INDESIT company

Model type:
BAAN12

Commercial code:
F044460

51520g0 Exploded views

N1030093fig1

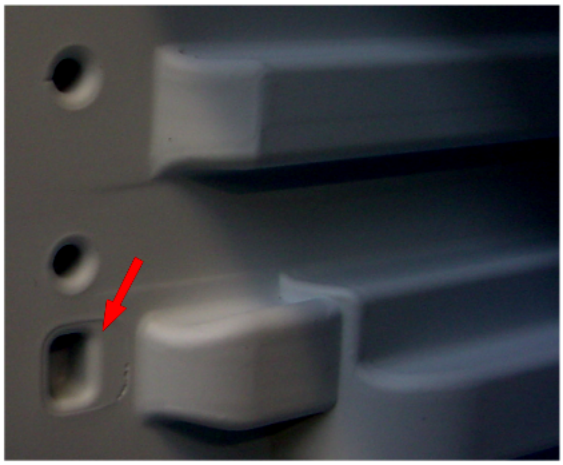
n1030093: New fixing of evaporator on static fridge-freezers (05 range) 60 cm,Melano

From August 05 (serial no. 50802.0001) the freezer evaporator is secured to the cabinet by a plastic profile.
The cabinet walls have been modified to create locations to house the profile, which is installed on the front of each evaporator plate (see photo N1030093fig1- fig2 - fig3)
The profile cannot be fitted on premodification appliances, so technical personnel must continue to fit the rh and lh supports on these models (see photo N1030093fig4)

New parts
C00141135 = WHITE PROFILE L=443.5 MM

Parts replaced
C00075596 = EVAPORATOR RH SUPPORT
C00075597 = EVAPORATOR LH SUPPORT
